Supplemental Design Revisions for 2015
Hudson River PCBs Superfund Site

Revised September 2015

Prepared for:
General Electric Company

Prepared by:
ARCADIS of New York, Inc.
6723 Towpath Road
P O Box 66
Syracuse
New York 13214-0066
Tel 315 446 9120
Fax 315 449 0017

**ARCADIS** FIGURE
1-2d

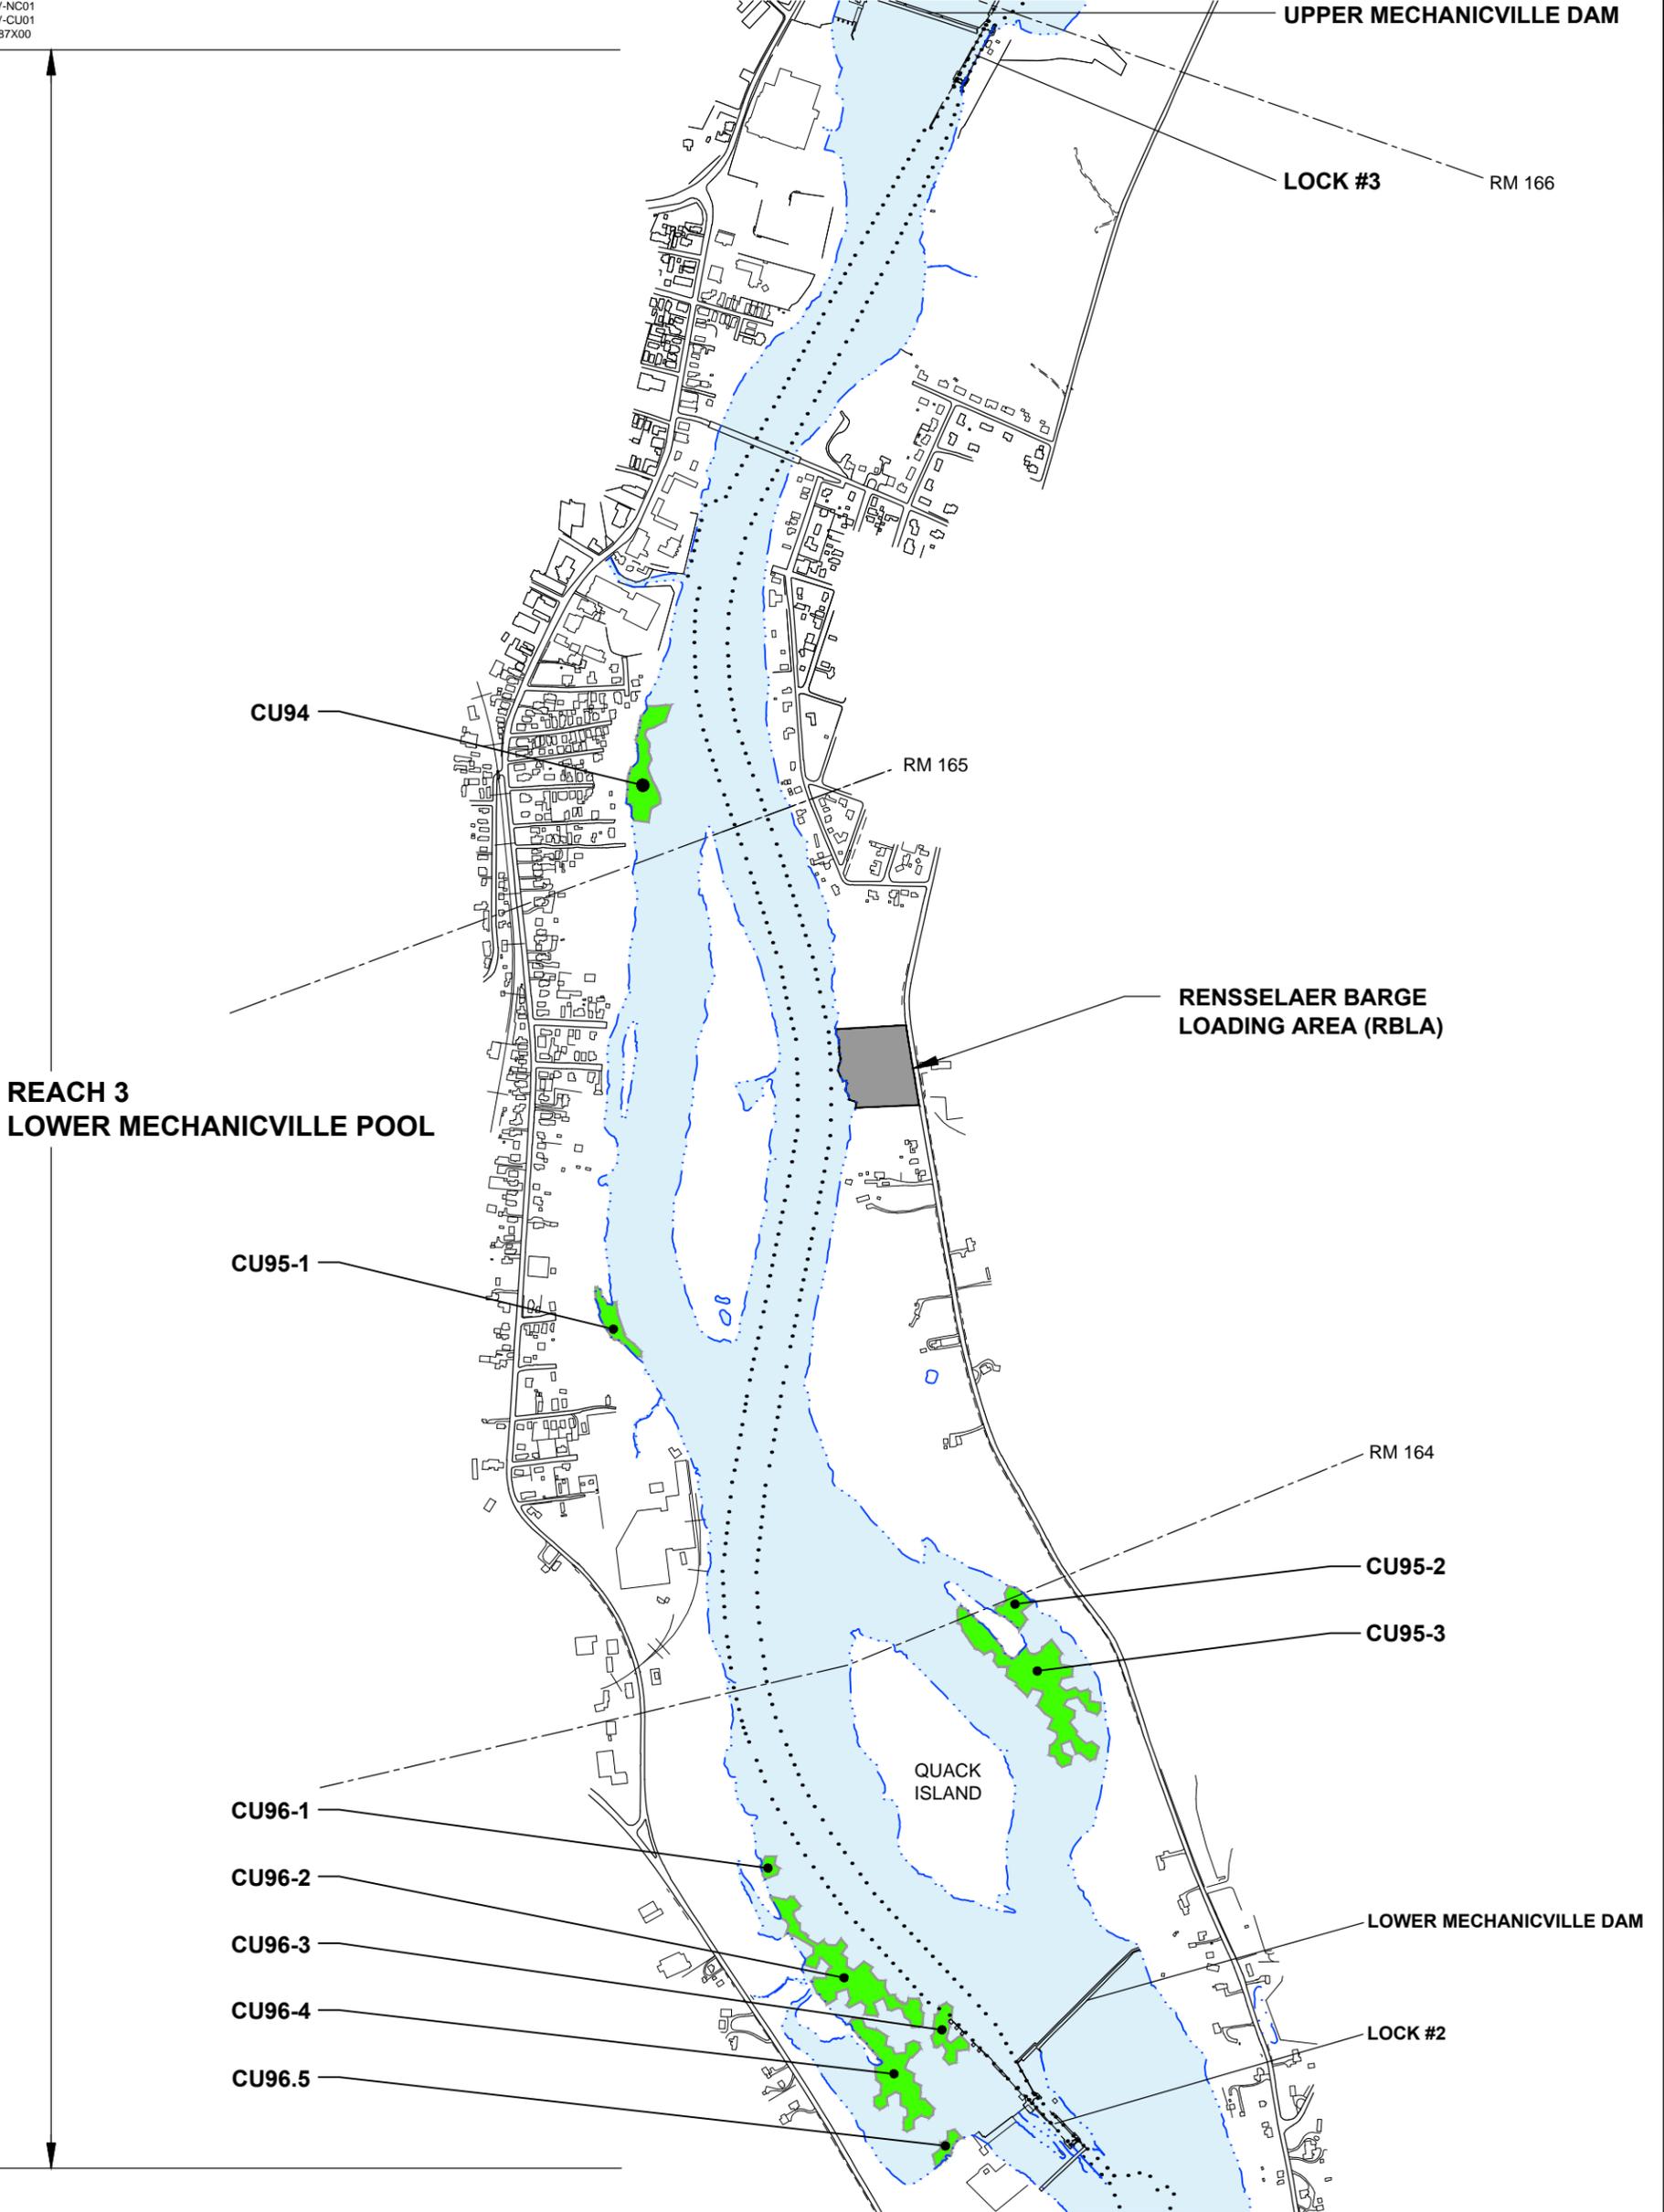
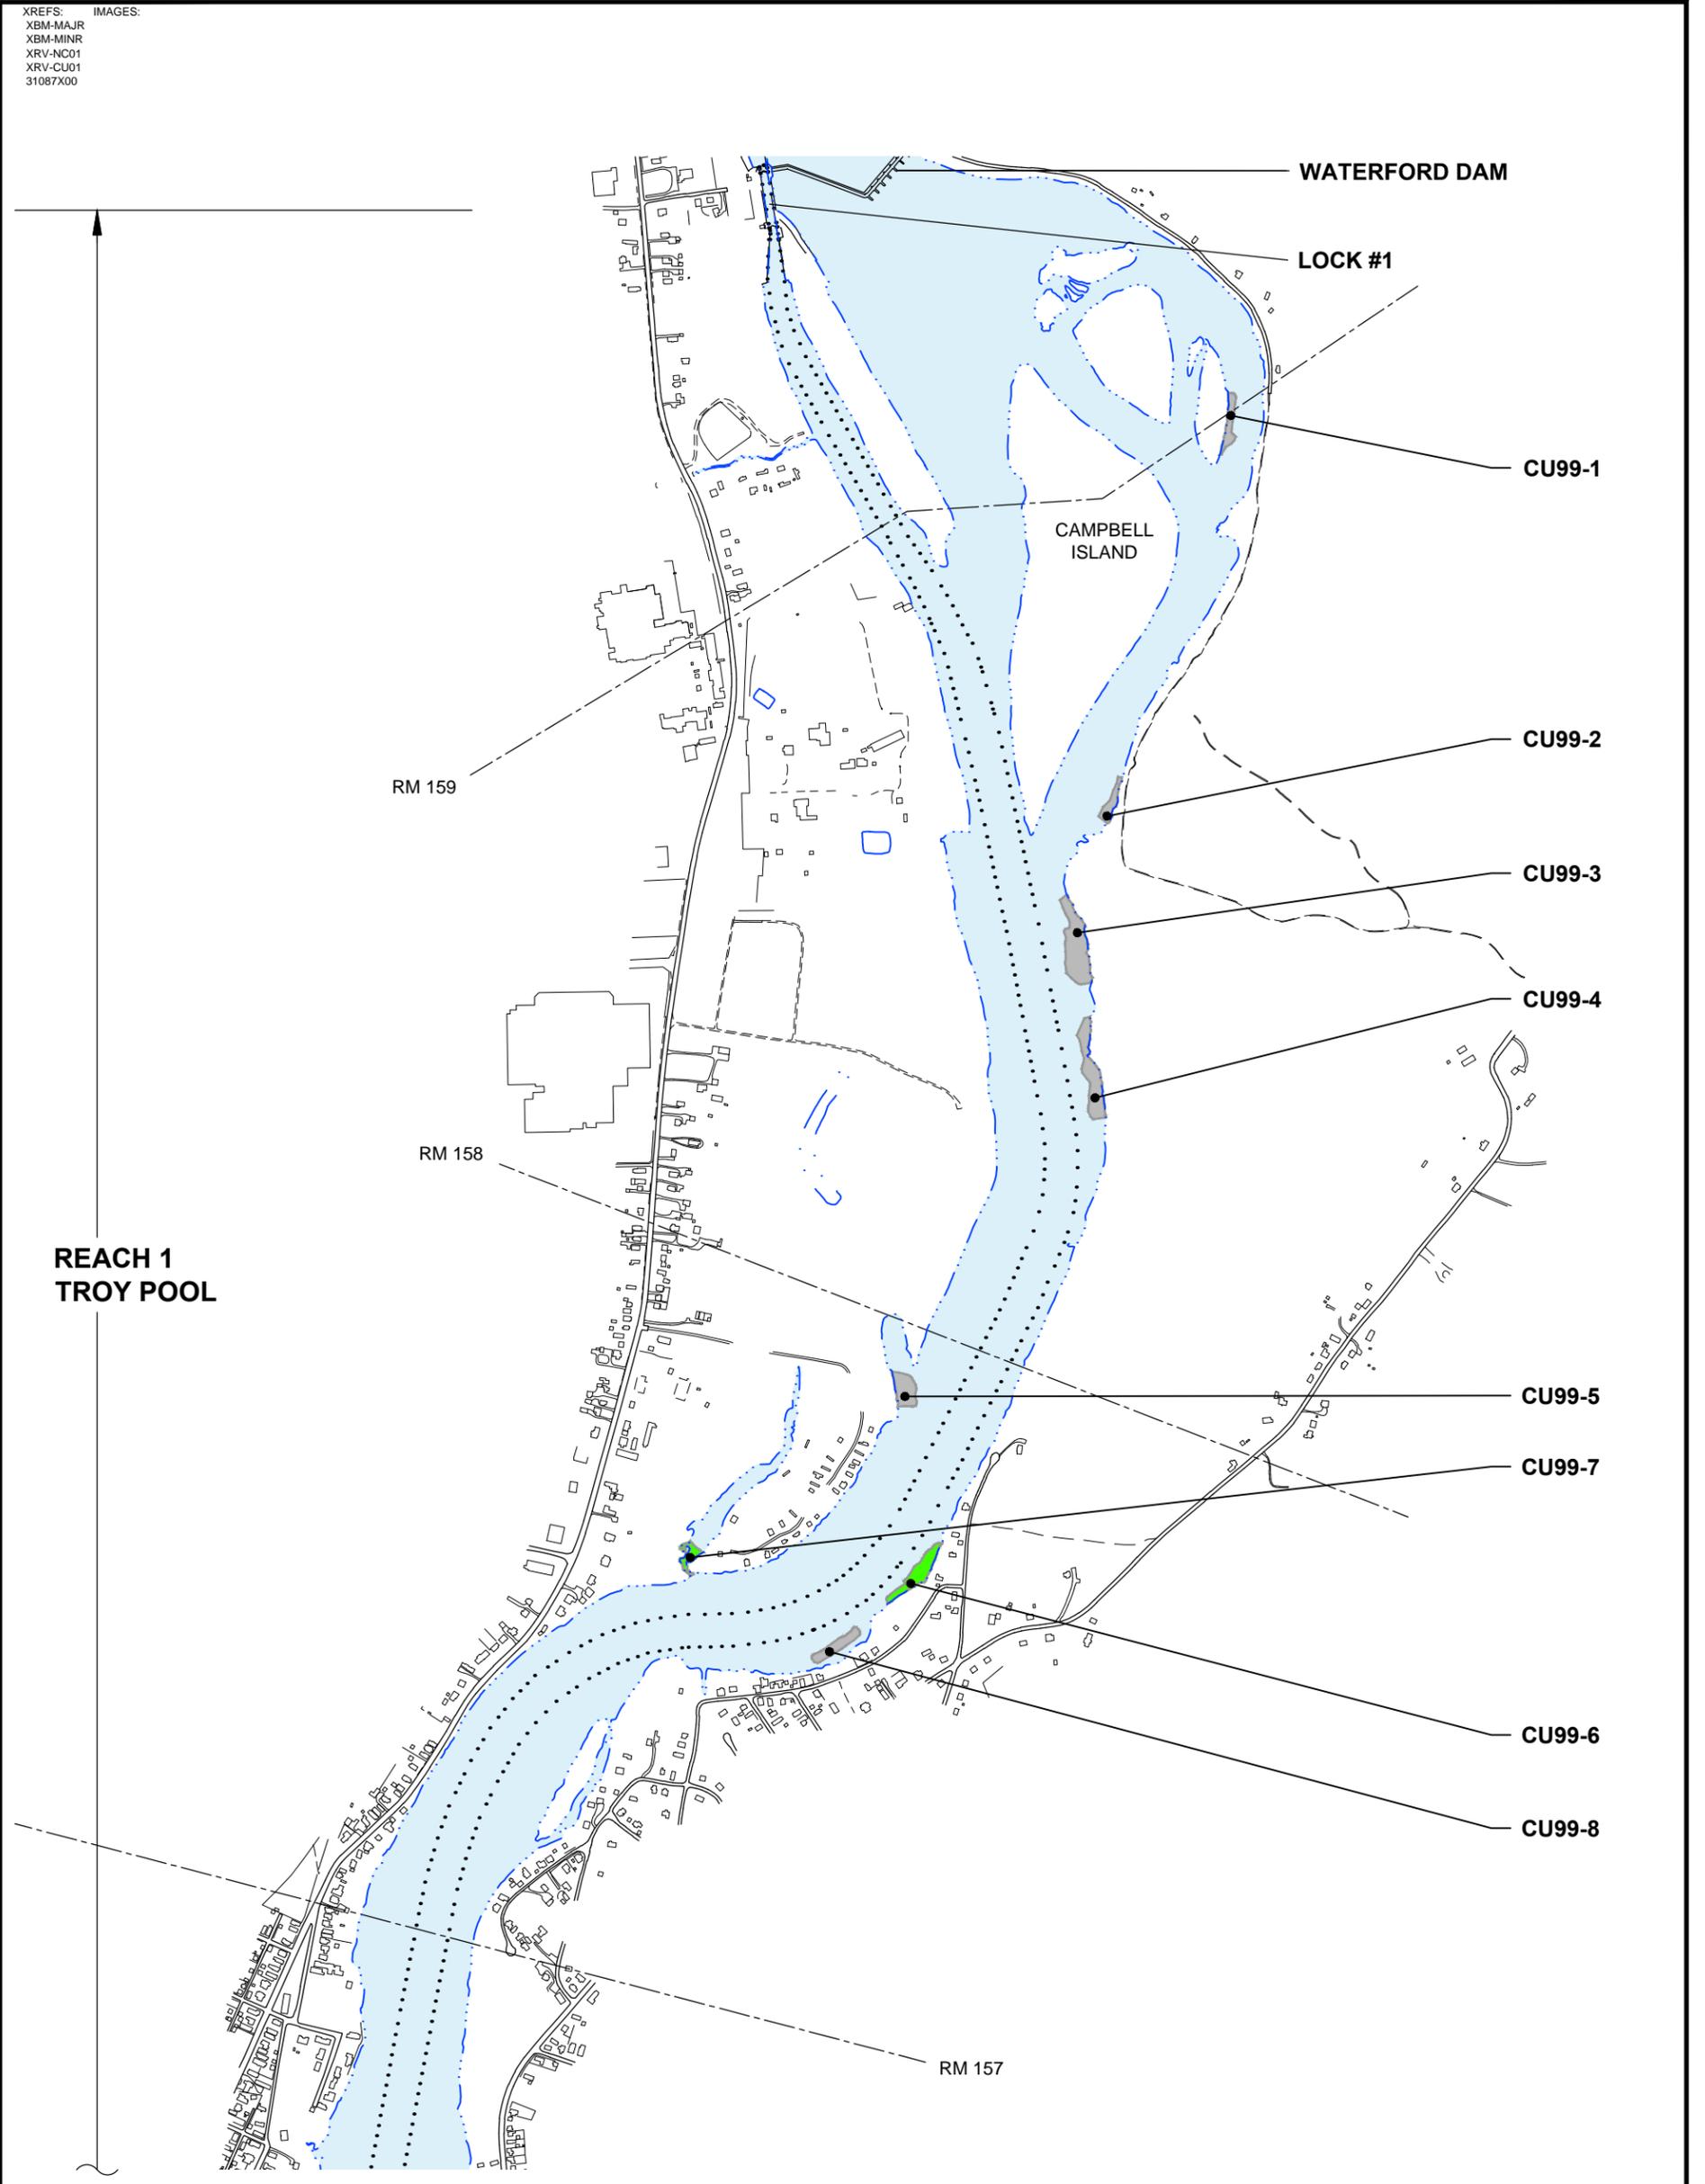
- An updated dredging and material transport approach for the portion of CU95 east of Quack Island (sub-units CU95-2 and CU95-3) was developed based on further evaluation of field conditions and access limitations to this portion of the river. In addition, the habitat construction design for that portion of CU95 has been revised based on comments provided by and discussions with EPA. Section 3 describes the updated dredging and material transport approach and the proposed habitat construction design revisions for sub-units CU95-2 and CU95-3.

**CERTIFICATION UNIT 60
 IN REACH 8**

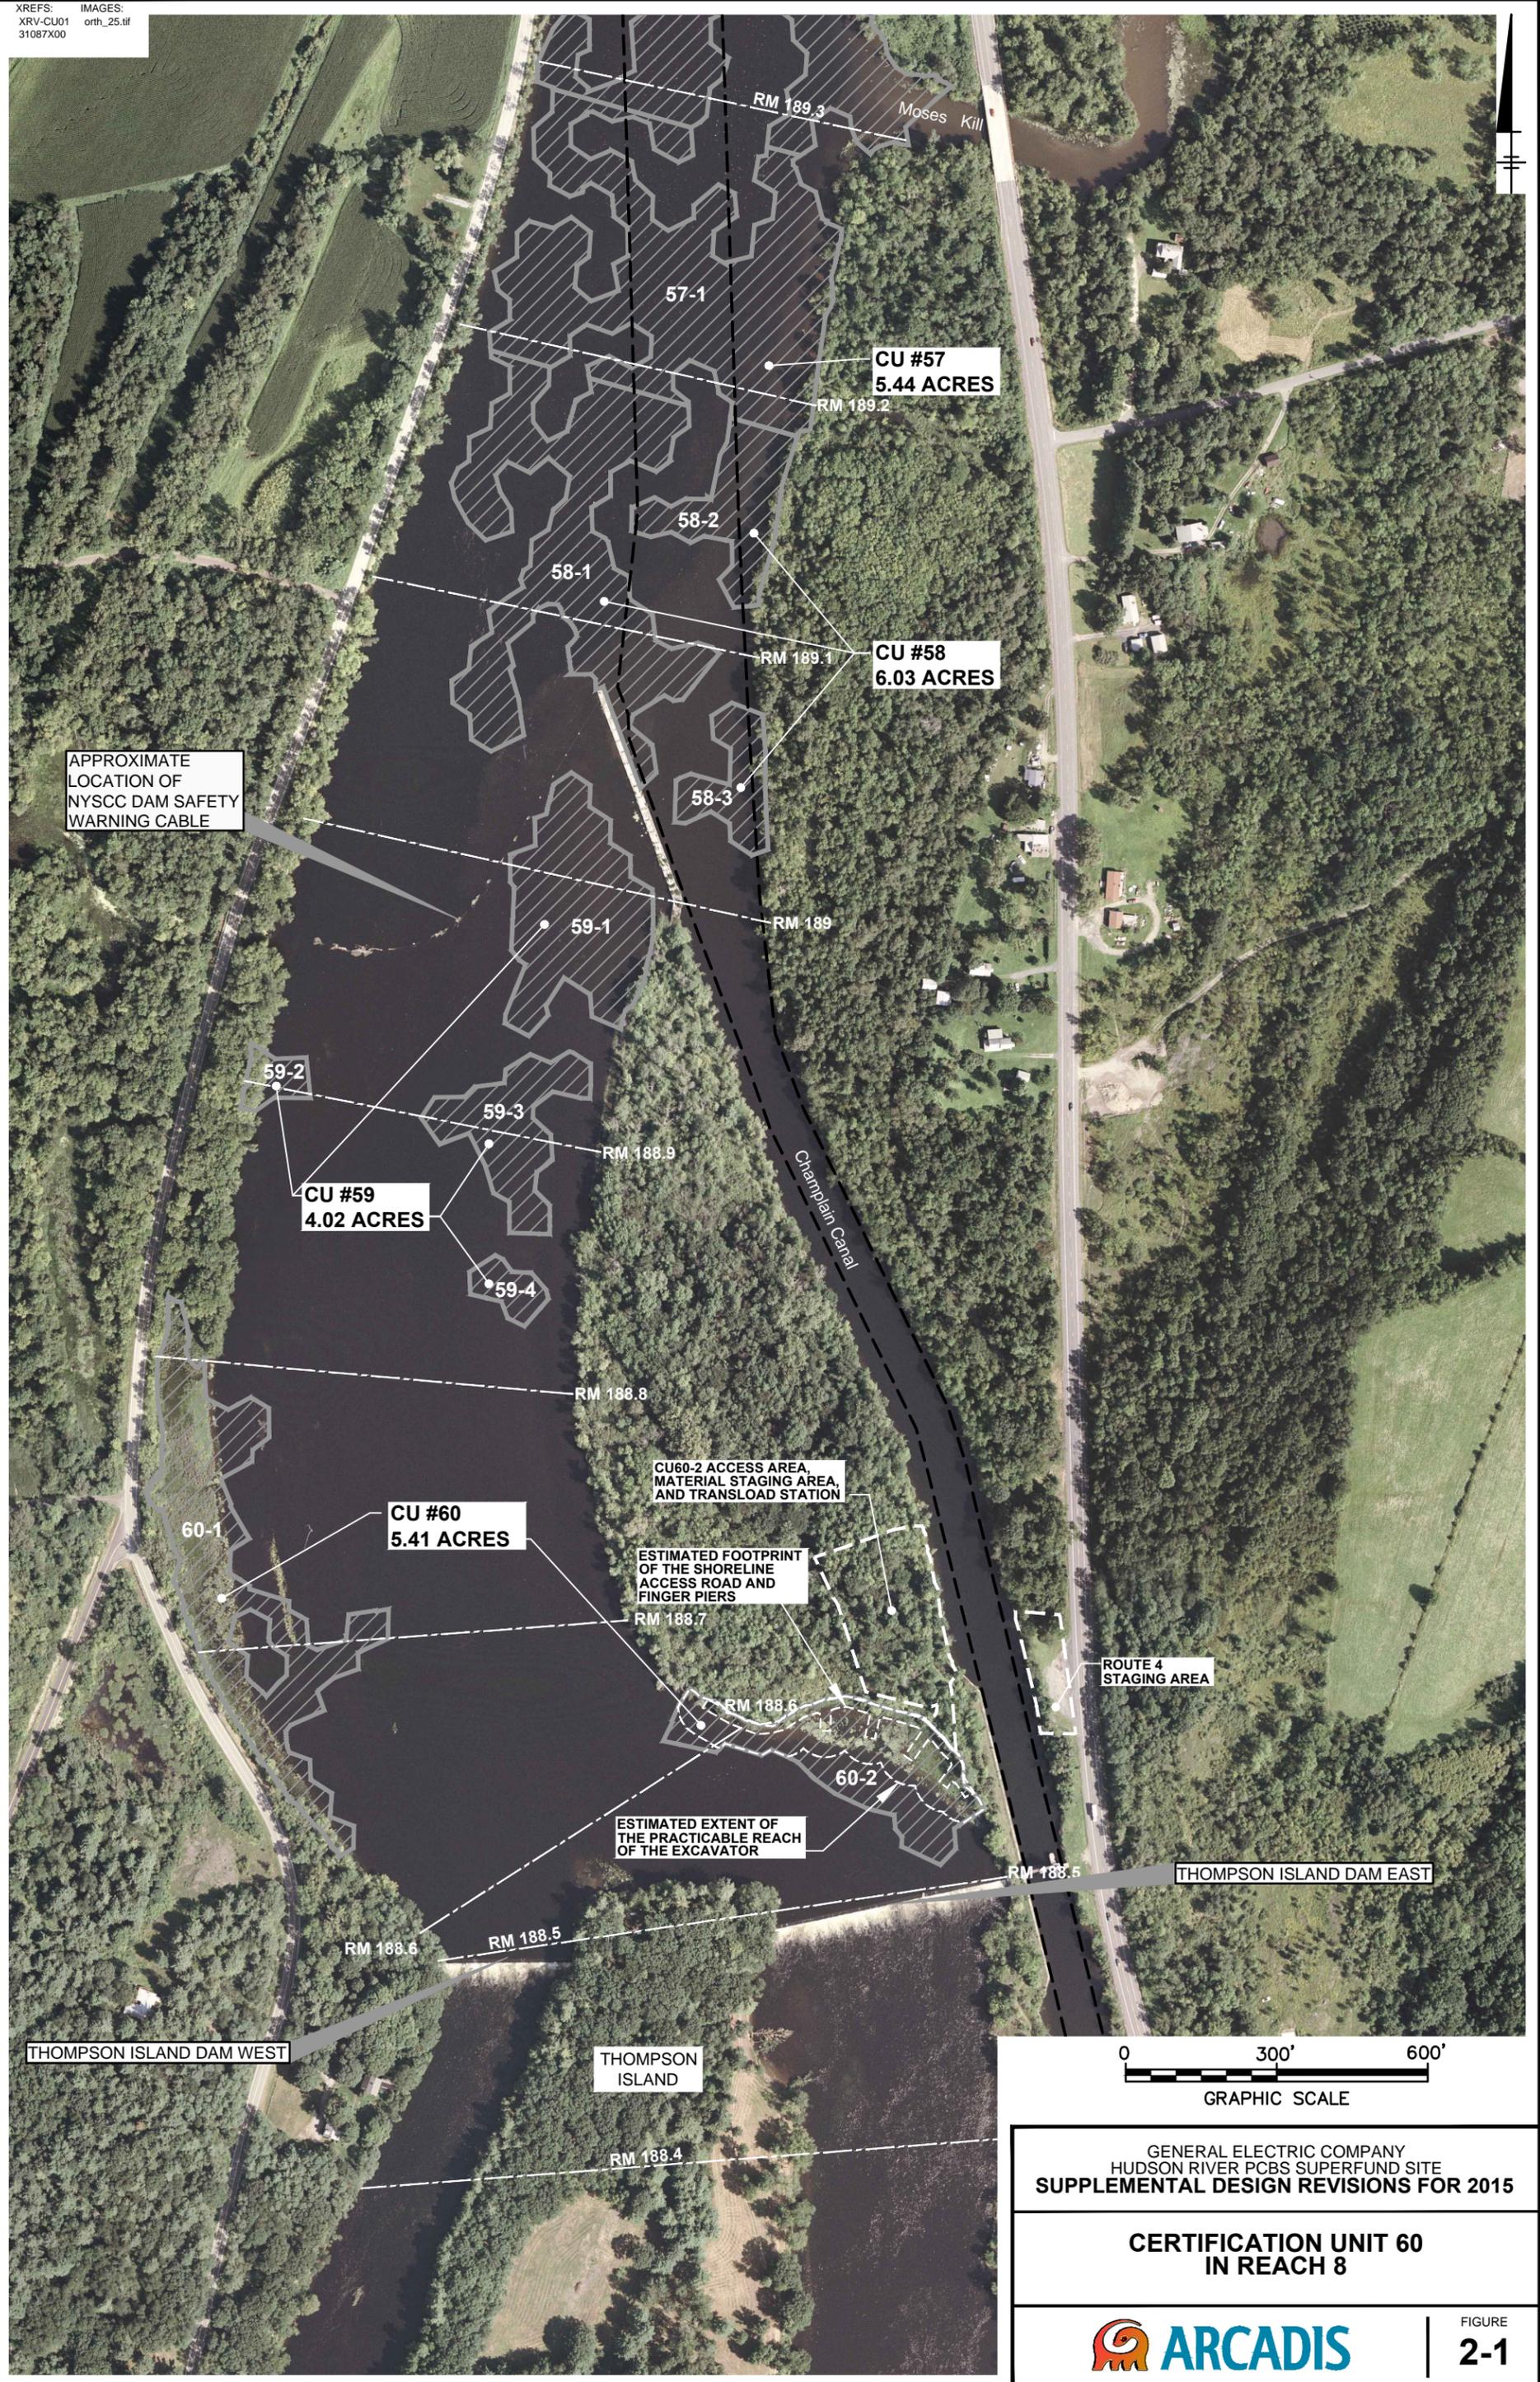
A staging area has been constructed on the eastern side of the Champlain Canal (Route 4 Staging Area), and a transload station, a material staging area, and access ways have been constructed on the western side of the canal. The locations of these areas are shown on Figure 2-1.
